CITY OF WILLARD, MISSOURI

MEETING AGENDA AND PACKET

PLANNING AND ZONING COMMISSION

June 25, 2019

Background Report for North Brooke Lot #5
Replat of lot #4 & #5

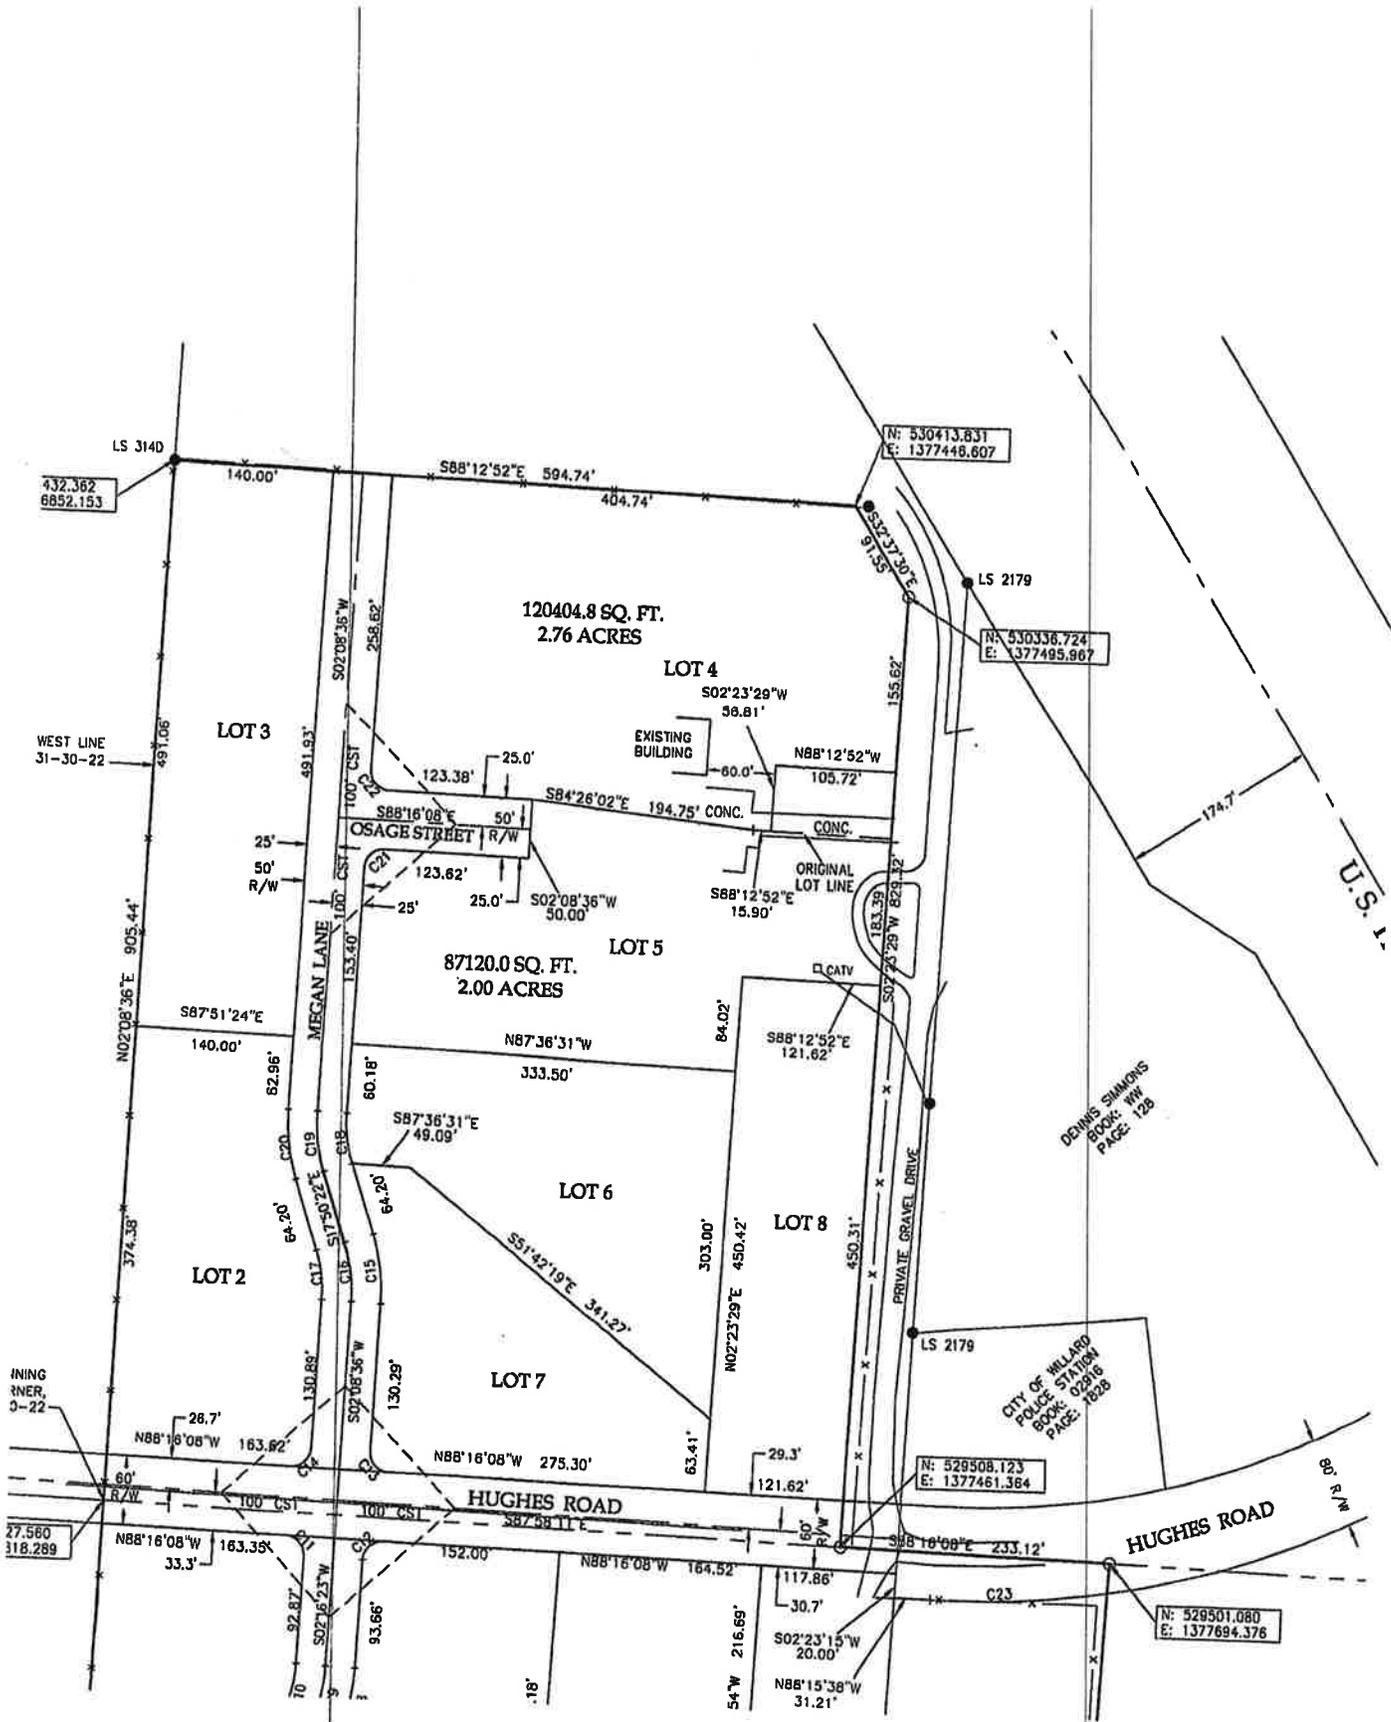
1. Lot 5 of the Northbrooke develop contains 1.86 acres.
2. Under the City's R-3 zoning that allows up to 12 units per acre, Lot 5 may have a maximum of 22 units.

3. Per section 400.440 Multi-family dwellings are required to have 3,000 square feet per dwelling unit. For 22 units this is 66,000 square feet. This regulation appears to be met.

4. Minimum lot width and depth are both met.
5. Maximum Structure height is 35 feet. I do not have the building plans. Please verify the building height.

6. The Front Yard, Rear Yard and Side Yards all appear to be met.
7. Parking required. Using 18 two bedrooms and 4 one bedrooms the required parking would be 62 stalls. It appears the development is short of parking. More lots will need to be added to meet the requirements.

8. After a layout is submitted that meets the parking the designer should show the open space ratio for the project. By code this must be 20% or larger.

9. Section 400.680 defines the required landscaping between the parking lot and the public right of way.
10. I see a temporary trash dumpster location. The final location must be screened from view.

11. Since Osage Street will not be extend east to Rocky Lane then the City should consider an easement to provide connectivity for trails or sidewalks connecting Megan Lane and the land to the east of this project. This would also enhance first responders' access and safety.
